工程名稱：亞皆老街中電

**No. RFI/A/230 (Rev. 0)**

**Subject Description: Query on Glass Door at G/F Multi-Function Room 3 (Midi's Ref.: RFI070)**

**Re : Design, Supply & Installation of Aluminium Window & Cladding, Curtain Wall, Glass Wall, Louvers and Glass Balustrade Nominated Sub-Contract at K.I.L. 6038RP, K.I.L.6037RP, K.I.L. 6036RP, K.I.L. 6035RP & K.I.L. 6005, Nos. 139-147 Argyle Street, Kowloon.**  
**Query on Glass Door at G/F Multi-Functional Room 3 (RFI070)**

**GROUND FLOOR PLAN**

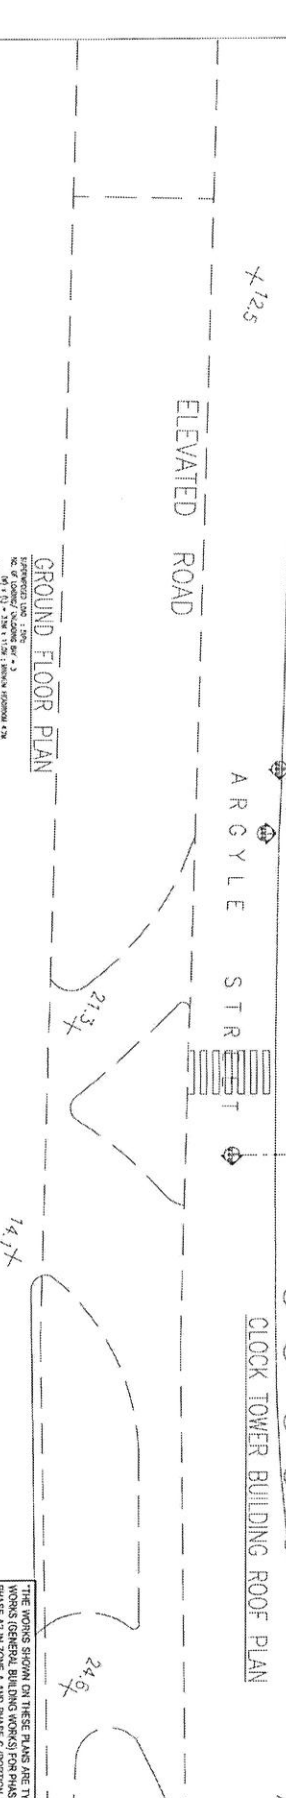
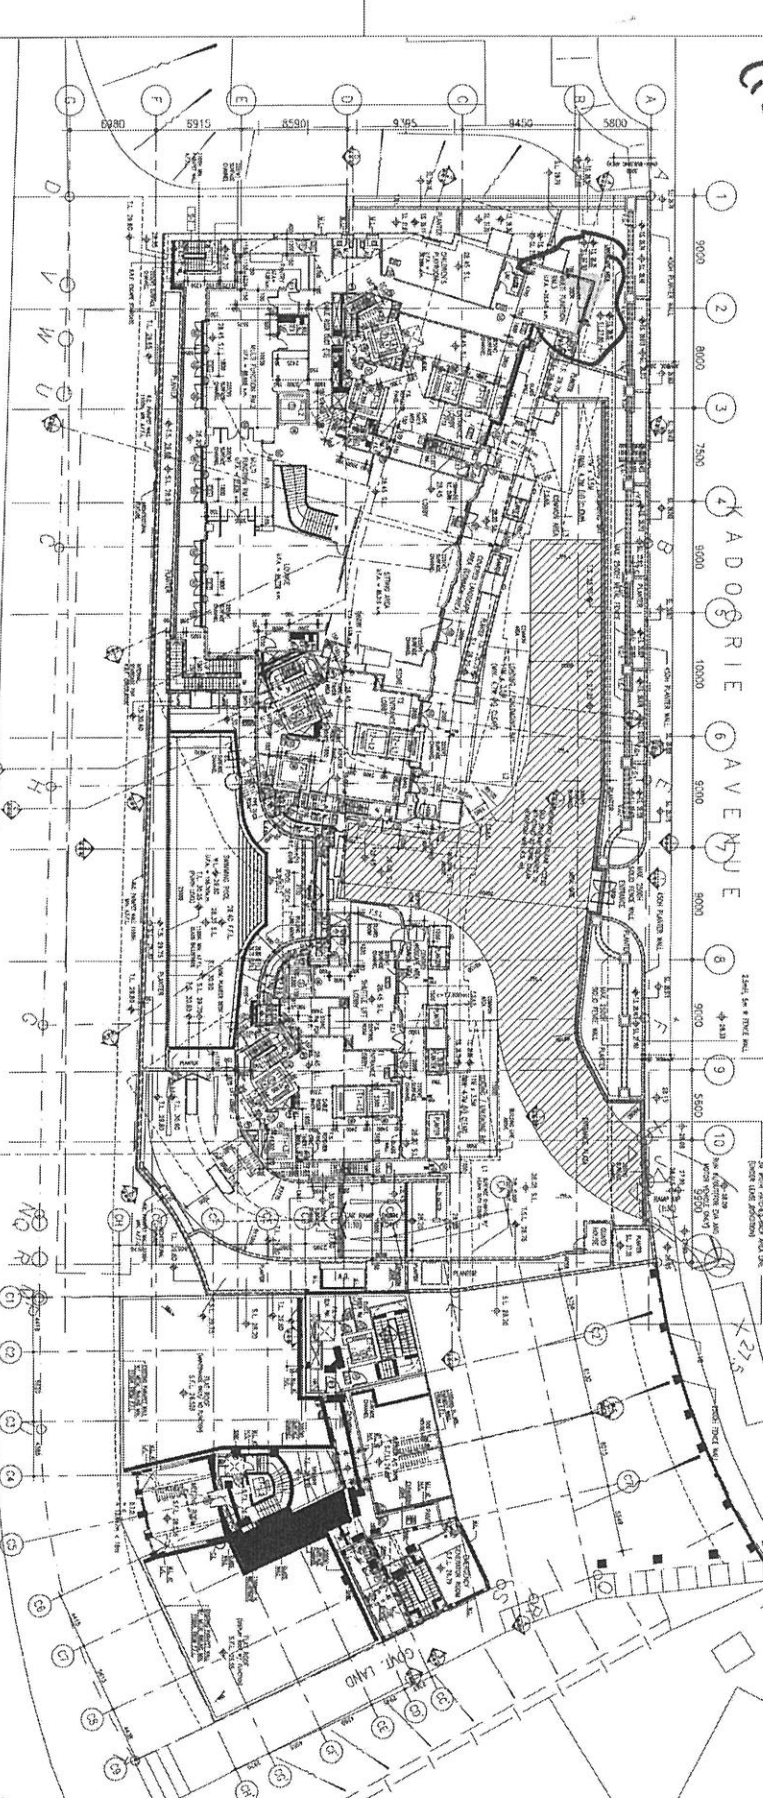
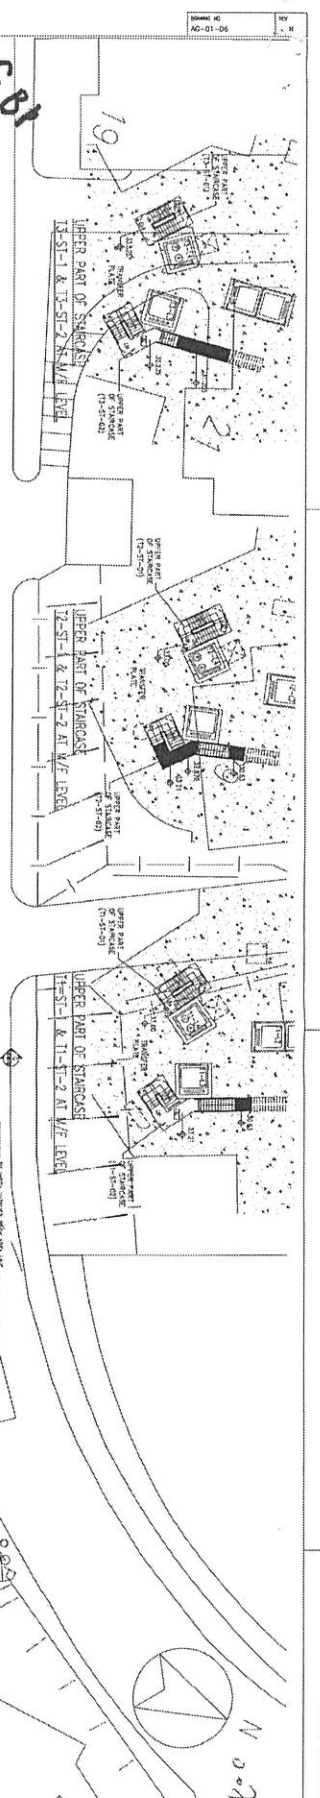
Regarding the captioned project, we would like to request the information about the Glass door at G/F Multi-Functional Room 3.

According to our tender drawing, it should be the Double Swing French Door at this location. And, referring to the latest GBP, it shows the Glass Door/ Sliding Door. Please Clarify which was kept under the midi scope. Please Issue A.I to cover the design change.

If proceed with new design, please provide the followings,

- 1) the design intent for the glass door :
- 2) The S.O. for Glass Door (Height x Width)
- 3) Setting out for Glass Door

Comment: **ATTACHED PHILIP LIAO'S FUNCTION ROOM LAYOUT PLAN FOR REFERENCE. TECHNICAL ISSUE SUBJECT TO ARCHITECT'S COMMENT AND APPROVAL**
